DEVELOPMENT APPLICATION ASSESSMENT REPORT

Application Number:	DA2019/0645
----------------------------	-------------

Responsible Officer:	Claire Ryan
Land to be developed (Address):	Lot 101 DP 611231, 26 Whistler Street MANLY NSW 2095
Proposed Development:	Demolition works, construction of a residential flat building and strata subdivision
Zoning:	B2 Local Centre
Development Permissible:	No - Existing Use Rights apply
Existing Use Rights:	Yes
Consent Authority:	Northern Beaches Council
Delegation Level:	NBLPP
Land and Environment Court Action:	No
Owner:	Proprietors of Strata Plan 15752
Applicant:	Boston Blyth Fleming Pty Ltd

Above: View looking west from a standing position across the subject site from Unit 506.

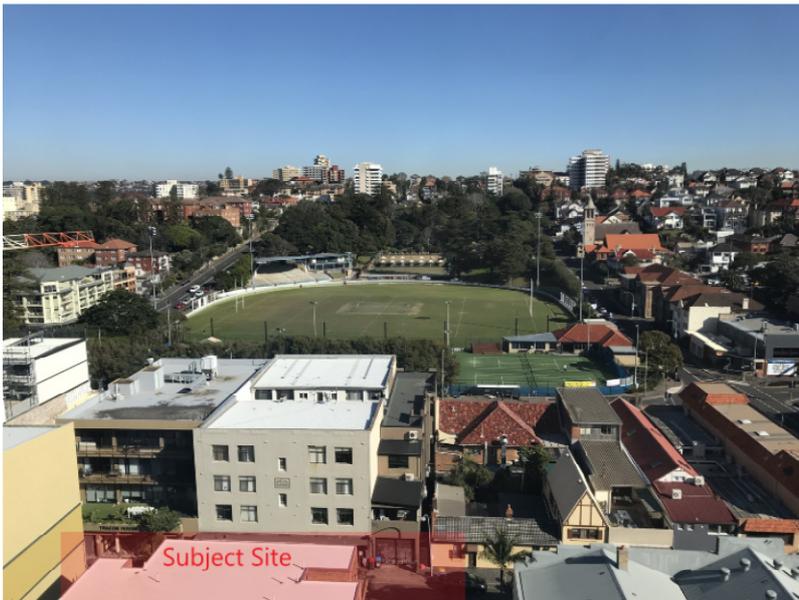
Concerns arise in relation to views from Units 506, 606, 813, and 912 of No. 22 Central Avenue, to the east of the subject site. Affected views are of other existing buildings and rooftops, Manly Oval and Ivanhoe Park. See photographs below, with the subject site identified with red shading. The red shading indicates the subject site only, and not the proposed building envelope.
